# WEST SUSSEX COUNTY COUNCIL CONSULTATION

<b>TO:</b>	Horsham District Council - FAO: Stephanie Bryant
<b>FROM:</b>	WSCC – Highways Authority
<b>DATE:</b>	30 October 2024
<b>LOCATION:</b>	Land To The South of Furners Lane Henfield West Sussex
<b>SUBJECT:</b>	DC/24/1538 Erection of 29 dwellings with associated landscaping, open space, parking and creation of new vehicular access
<b>RECOMMENDATION:</b>	More Information

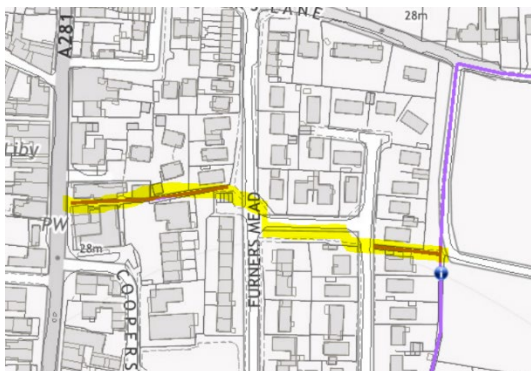
Para. 5.6 of the TS states that the existing property and farm will be served from the new access point. However, it does appear that the farm has an existing access further east on Furners Lane. The LHA raise some concern with the potential for farm traffic to be using the new access and residential roads.

- LHA raise concern on Backsetttown farm being accessed through the site. Why is this required if access to farm already exists east on Furners Lane? There could be conflict between large agricultural vehicles and resident vehicles.
